Pedestrian Road Safety Audit Public Document

MD 97 (Georgia Avenue) at Randolph Road

Montgomery County
July 2014

STV Incorporated
Baltimore, Maryland

Figure 9: Discontinuity of Pedestrian Path – Phase 2A

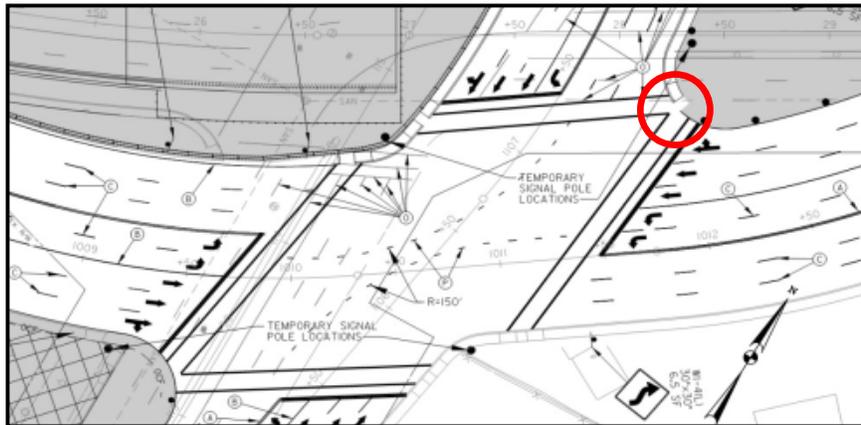
Some of the pedestrian paths were obstructed and/or were not ADA accessible as shown on the plans. For example, as shown in **Figure 9**, the sidewalk on the northeast corner of the MD 97 at Randolph Road intersection did not extend around the radius of the curve. This may cause difficulty for the physically disabled to access the ramps and may lead pedestrians into the work zone. Therefore, it was recommended that the sidewalk be extended around the corner. Similar changes were recommended for any other obstructed or non-accessible pedestrian paths. In response, SHA added additional construction fencing and signs to clearly delineate the pedestrian pathway.

Figure 10: Inadequate Crosswalk and Pedestrian Related Signage

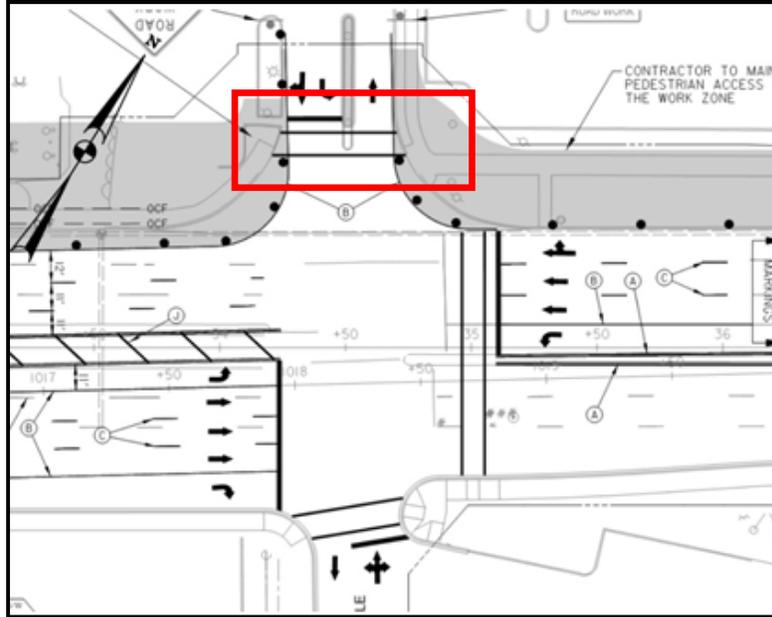
Crosswalks and pedestrian-related signage were not identified at some intersections and crosswalks. For example, during MOT Phase 2A at the Randolph Road at Glenmont Circle intersection, the pedestrian crosswalk on the north leg appeared to be too far removed from the intersection (**Figure 10**). With excess distance between the crosswalk and the intersection, westbound right-turning vehicles may not be aware of pedestrians in the crosswalk. It was suggested that “Watch for Pedestrians” or “Turning Traffic Yield to Peds” signs be installed on the westbound approach, and at any other similar location. In response, SHA added additional signs to notify vehicles of the presence of pedestrians.

Figure 12: Sequence of Construction (MOT Phase 3 (Left) and Temporary Roadway Plan Phase 3A (Right))

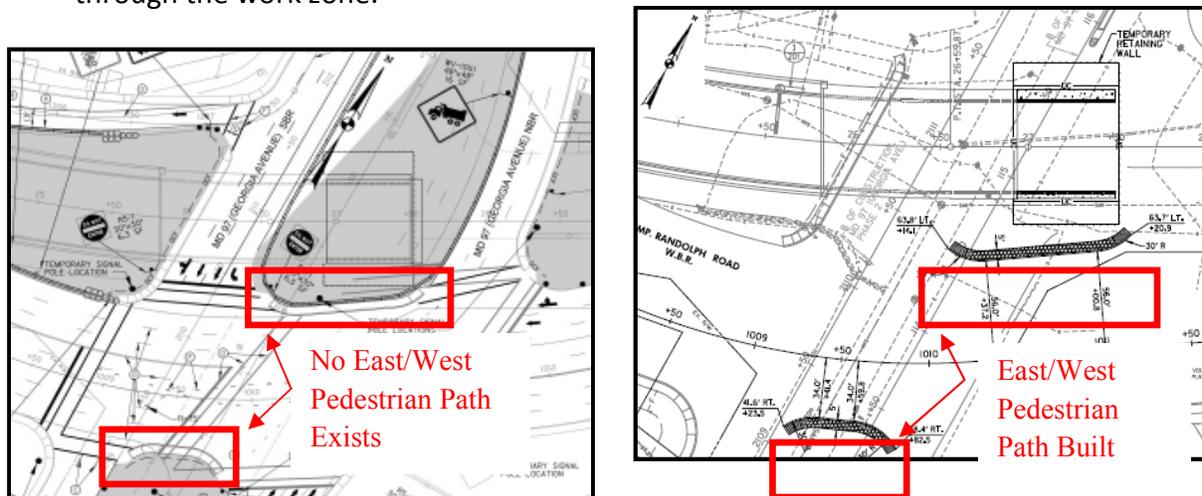
The sequence of construction did not show when roadway, sidewalks, or other items were to be constructed in some locations. For example, Phase 3 of the MOT was not consistent with temporary roadway plans for Phase 3A at the intersection of MD 97 at Randolph Road (**Figure 12**). Both the north and south median sidewalks were being constructed in Phase 3A; however, MOT Phase 3 indicated the sidewalks were temporary for pedestrian crossings. Since the sidewalks were not constructed, pedestrian paths under MOT Phase 3 were not clearly defined for the east/west pedestrian path through the intersection. Therefore, it was recommended that the phasing of construction be modified to construct the north median first followed by the south median, so that there will be an east/west path available through the intersection. Any other locations with a similarly unclear path were also recommended for modification. In response, SHA reviewed the sequence of construction to ensure that the contractor will be maintaining pedestrian access through the work zone.

Figure 13: Inadequate Work Zone Protection

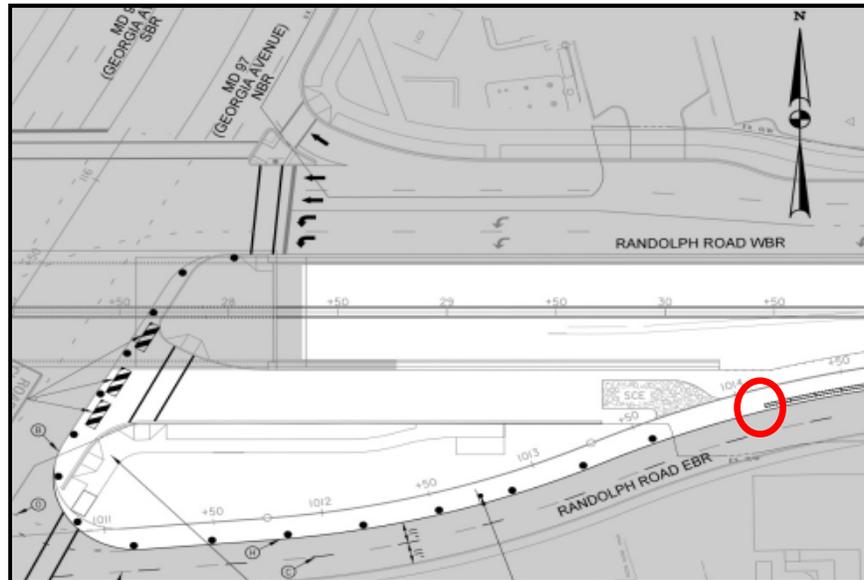
Adequate protection was not provided for some of the work zone areas. For example, during MOT Phase 5B, there was no crash cushion specified for the western end of the temporary concrete barrier east of the intersection of MD 97 at Randolph Road (**Figure 13**). It was recommended that an impact attenuator be installed at the end facing into the flow of traffic at this location. In response, SHA added an impact attenuator at this location.

Figure 15: Inadequate Turning Radii

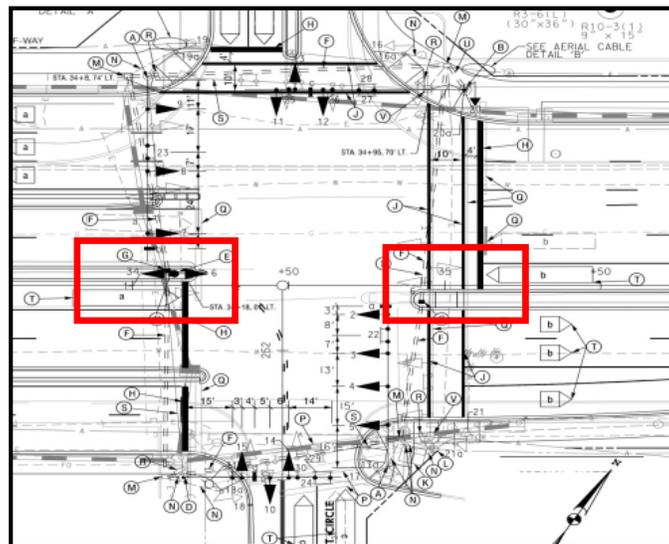
At the intersection of Randolph Road at Glenmont Circle, the proposed east and westbound U-turn radii appeared to be limited and may not have been adequate to complete a U-turn maneuver (**Figure 15**). It was suggested that U-turns be prohibited for the east- and westbound directions. In response, SHA altered the traffic signal phasing to include an exclusive east- and westbound left turn movement, removing the need to prohibit U-turn maneuvers.

Figure 16: Lack of Signage for Left-Turn Prohibitions

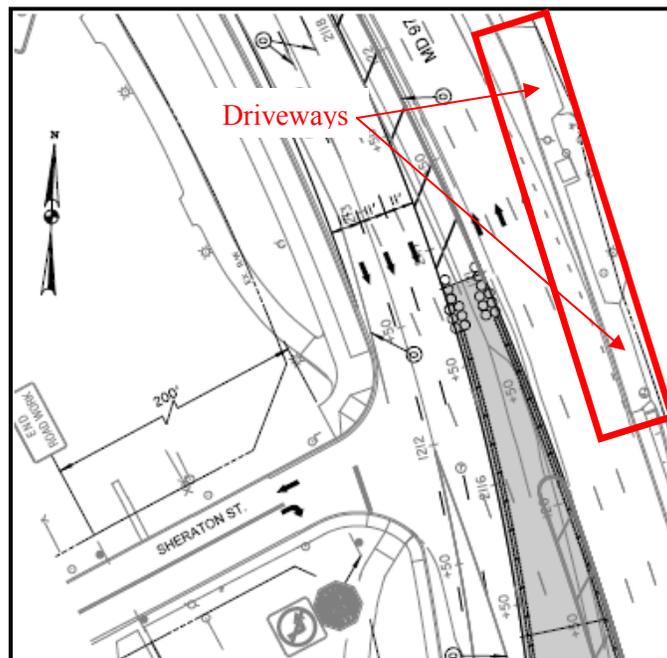
Movement prohibition signage informs drivers of illegal and unsafe turning movements. Lack of appropriate movement prohibition signage or confusing signage may impact safety. For example, the driveways on the east side of MD 97 north of Sheraton Street did not have signage restricting left turns exiting the driveways (**Figure 16**). Since the existing median along MD 97 will be removed during some construction phases, vehicles from the driveways could attempt to make left turns onto southbound MD 97. In order to prevent this maneuver, it was suggested that “No Left Turn” signs and/or “Right Turn Only” signs and “One Way” signs be installed to guide vehicles exiting these driveways. In response, SHA added the additional movement prohibition signage at this location.

Figure 17: Lack of Pedestrian Detour Signage

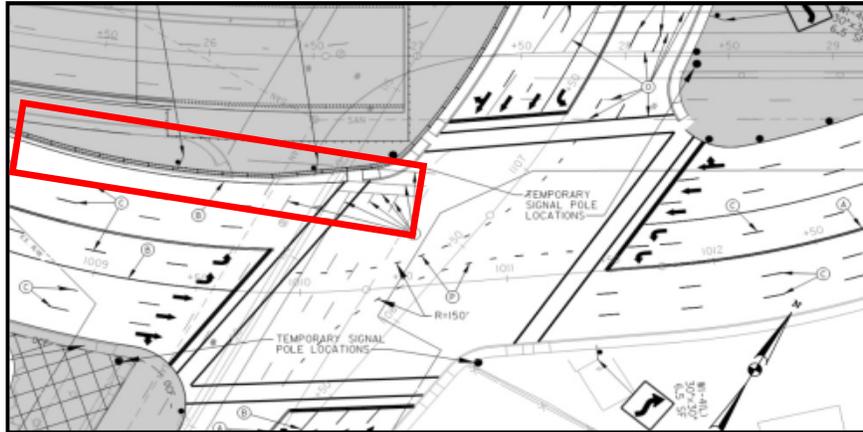
Without appropriate signage, roadway and sidewalk closures may lead to pedestrian and/or driver confusion. One such situation was found on MOT Phase 2A plans at the intersection of MD 97 and Randolph Road. No pedestrian detour signage was proposed between MD 97 (Georgia Avenue) and Judson Road north of Randolph Road, where the

sidewalk will be closed. Without pedestrian detour signage, pedestrians may attempt to cross at an unmarked location and travel through the construction zone to reach Judson Road (**Figure 17**). “Sidewalk Closed” signs were recommended at this location, along with pedestrian detour signs on the northwest corner of the MD 97 and Randolph Road intersection leading pedestrians to access Judson Road from Sheraton Street. Any other similar sidewalk closures and pedestrian detours were recommended for additional signage. In response, SHA added additional signage to detour pedestrians in the westbound direction.

Figure 18: Work Zone Signage Location

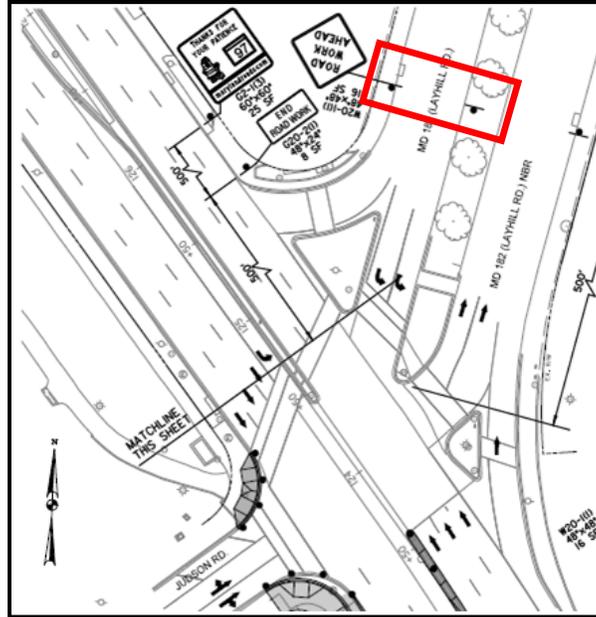
During MOT Phase 1A, the “Road Work Ahead” sign proposed on the westbound approach of the Layhill Road intersection with MD 97 appeared to be too close to the intersection (**Figure 18**). This may not have given adequate advanced notice regarding the work zone for motorists, in particular the westbound left-turning vehicles, to be prepared for the change in conditions. The “Road Work Ahead” sign on the westbound approach was recommended to be moved further ahead of the intersection. In response, SHA identified the offset dimension from the intersection to the sign and added clarification on the sign in the median of Layhill Road.

| Sheet 69 of 309 (Phase 1A) | | Maintenance of Traffic Plan | |
|-------------------------------------------------------------------------------------------------------------------------------------------------------------------------------------------------------------------------------------------------------|---------------------------------------------------------------------------------------------------------------------------------------------------------------------------------------------------------------------------------------------------------------------------------------------------------------------------------------------|----------------------------------------------------------------------------------------------------------------------------------------------------------------------------------------------------------------------------------------------------------------------------------------------------------------------------------------------------|---------------------------------------------------------------------------------------------------------------------------------------------------------------------------------------------------------------------------------------------|
| <p>1. The "Road Work Ahead" sign proposed on the WB approach of Layhill Road intersection appears to be too close to the intersection and may be only on the north side of Layhill Road.</p> | <p>1.1. The drivers may not get adequate advance notice regarding the work zone ahead.</p> <p>1.2. The left-turning vehicles may not be able to see the (Road Work Ahead) sign and may not be prepared adequately for the change in conditions.</p> | <p>1.1. Consider installing the "Road Work Ahead" sign on the WB approach further ahead of the intersection.</p> <p>1.2. Consider installing the "Road Work Ahead" sign in the median for the WB left-turning vehicles.</p> | <p>1.1. A dimension will be provided to offset the sign from the intersection.</p> <p>1.2. A leader will be added to the proposed sign in the median.</p> |

Figure 19: Example of Lack of Pavement Markings

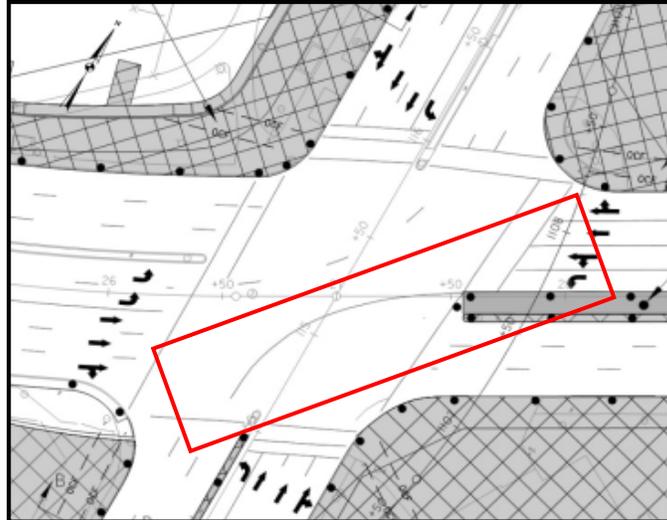
During MOT Phase 1B at the intersection of MD 97 at Randolph Road, no temporary lane line extension markings were provided for the westbound dual left-turn lanes (**Figure 19**). Without designated lane markings, there was potential that two westbound left turning vehicles in adjacent lanes could collide. Therefore, it was recommended that lane line extension markings be installed through the intersection to provide positive guidance for the westbound left-turning movements. In response, SHA added temporary lane extension pavement markings for the westbound dual left turn lanes.

| Sheet 70 of 309 (Phase 1B) | | Temporary Traffic Signal Plan | |
|------------------------------------------------------------------------------------------------------------------------------------------------------------------------------------------------------------------------------------------------|-----------------------------------------------------------------------------------------------------------------------------------------------------------------------------------------------------------------------|--------------------------------------------------------------------------------------------------------------------------------------------------------------------------------------------------------------|-------------------------------------------------------------------------------------------------------------------------------------------|
| <p>N. Vehicle safety at the MD 97 and Randolph Road intersection.</p> <p>1. No temporary skip markings are provided for the WB dual left-turn lanes.</p> | <p>1. Without clear path, WB dual left-turns may create a potential for side swipe crashes.</p> | <p>1. Consider installing skip markings for the WB left-turning movements.</p> | <p>1. Temporary lane extension pavement markings will be added to the plans.</p> |

Figure 20: Lack of Pavement Markings for Lane Shift

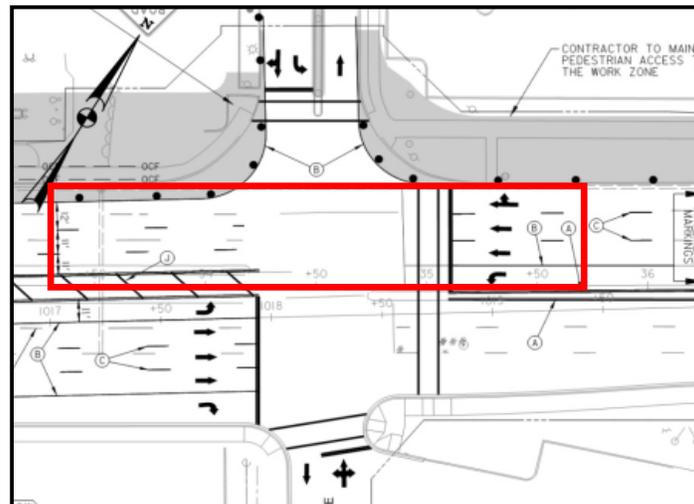
During MOT Phase 2A the westbound through lanes shift slightly through the intersection of Randolph Road at Glenmont Circle (**Figure 20**). An unexpected shift in lanes can lead to side swipe collisions. It was suggested that lane line extension markings be installed through the intersection for the westbound through lanes. In response, SHA reviewed the alignment of westbound through movements and determined that lane line extension markings were not necessary.

| Sheet 73 of 309 (Phase 2A) | | Maintenance of Traffic Plan | |
|------------------------------------------------------------------------------------------------------------------------------------------------------------------------------------------------------------------------------------------------------------------------------------------------------------------------------------------------------------------------------------------------------------------------------------------------------------------------------------------------------------------------------------------------------------------------------------------------------------------------------------------------------|--------------------------------------------------------------------------------------------------------------------------------------------------------------------------------------------------------------------------------------------------------------------------------------------------------------------------------------------------------------------------------------------------------------------------------------------------------------------------------------------------------------------------------------------------------------------|---------------------------------------------------------------------------------------------------------------------------------------------------------------------------------------------------------------------------------------------------------------------------------------------------------------------------------------------------------------------------------------------------------------------------------------------------------------------------------|---------------------------------------------------------------------------------------------------------------------------------------------------------------------------------------------------------------------------------------------------------------------------------------------------------------------------------------------------------------------------------------------------------------------------------------------------------------------------------------------------------------------------------|
| <p>S. Vehicle safety at the Randolph Road and Glenmont Circle intersection.</p> <p>1. Proposed excavation work creates a drop off of > 6 inches in work area.</p> <p>2. The WB through lanes shift slightly through the intersection.</p> <p>3. The median areas on the east and west legs of the intersection are not rounded/closed.</p> | <p>1. Barrels may not provide adequate protection from drop off for vehicles.</p> <p>2. An unexpected shift in lanes may lead to side swipe collisions.</p> <p>3. The NB and SB left-turning vehicles may have difficulty in identifying the travel path without closed/rounded medians.</p> | <p>1. Consider installing temporary concrete barrier.</p> <p>2. Consider installing skip markings through the intersection for the WB through lanes.</p> <p>3. Consider installing hatched bullet nose medians on the east and west legs of the intersection.</p> | <p>1. Standard drop off procedures will be followed by the contractor.</p> <p>2. The shift will be investigated to determine if lane extension markings are necessary.</p> <p>3. Additional markings will be added.</p> |

Figure 21: Lack of Driveway Access

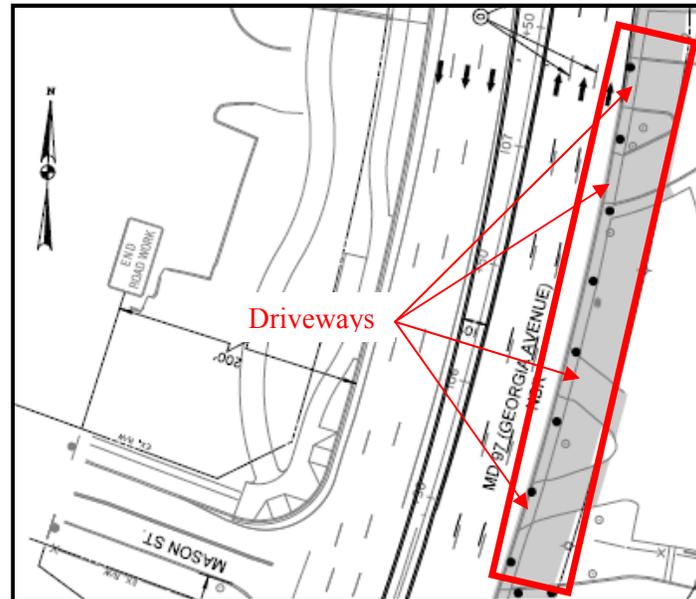
Access to commercial properties and driveways was not clearly defined during some of the MOT phases. For example, the commercial driveways on the east side of MD 97 north of Mason Street were shown as part of the work zone area during MOT Phase 4A (**Figure 21**). Drums to delineate access to all commercial businesses were recommended throughout the work zone for this and any other similar areas. In response, SHA added additional drums to identify driveways and maintain access.

| Sheet 86 of 309 (Phase 4A) | | Maintenance of Traffic Plan | |
|-------------------------------------------------------------------------------------------------------------------------------------------------------------------------------------|-------------------------------------------------------------------------|------------------------------------------------------------------------------------------------------------------------|-----------------------------------------------------------------------------|
| <p>OO. Vehicular safety at the MD 97 and Glenmont Circle intersection.</p> <p>1. Commercial driveways to the east side of MD 97 are shown as part of the work zone.</p> | <p>1. Access to the commercial driveways from MD 97 is blocked.</p> | <p>1. Consider installing drums or barrels to delineate access to all commercial businesses through the work zone.</p> | <p>1. Access to the driveways will be maintained and shown on the plan.</p> |

Figure 22: Accessibility Issues to Bus Stop

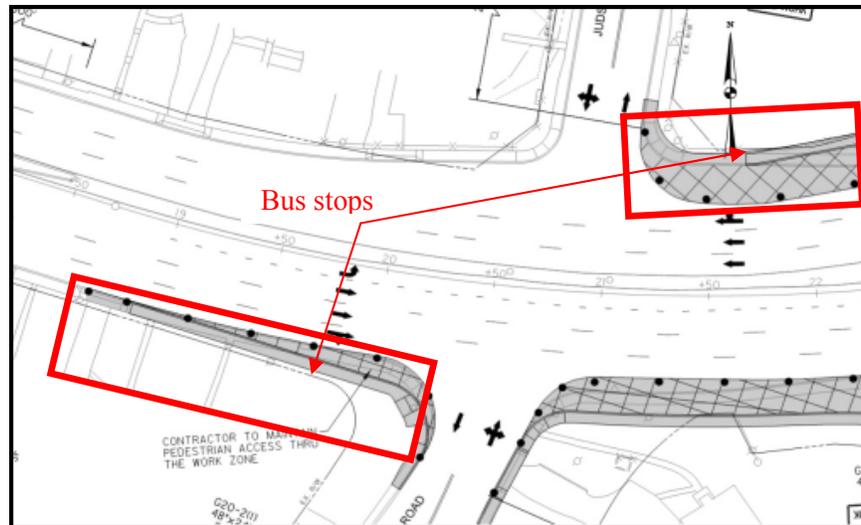
Based on a review of the design plans, several bus stop locations were impacted by the work zone. However, it was not clearly identified if and how these facilities would be maintained. As an example, during MOT Phase 1A on Randolph Road near Judson Road, there are existing bus stops located in the work zone (**Figure 22**). Improper or inadequate waiting areas and paths may block the sidewalk for pedestrians, and riders wanting to board the bus may have to traverse the construction zone. It was recommended for this location and any other similar locations, that waiting areas and clear access to/from the bus be provided. In response, SHA coordinated with Montgomery County and WMATA, and all temporary and permanent bus stops have been modified as necessary to provide appropriate access.

Figure 23: Landscaping Interference with Pedestrian/Vehicle Operations

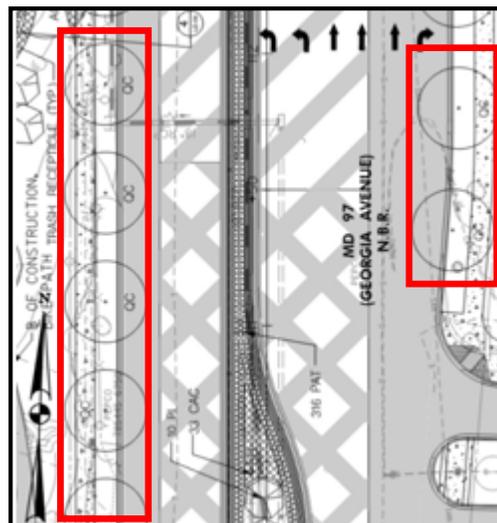
Some of the landscaping and lighting details on the design plans appeared to potentially interfere with pedestrian/vehicular traffic operations. For example, the proposed trees in the landscaping plans along north- and southbound MD 97 appear to be in close proximity to the roadway (**Figure 23**). Given the proportion of large vehicles using this roadway, trees may be struck by trucks, potentially leading to sudden avoidance maneuvers and damage to street trees. Therefore, it was recommended that appropriate species of trees and foliage be chosen to minimize encroachment on the roadway, and/or consider the feasibility of relocation (or removal) of the proposed trees to avoid interference with large vehicles for this and any other similarly situated plantings. In response, SHA reviewed the proposed tree placement and changed the placement to reduce encroachment on the roadway.
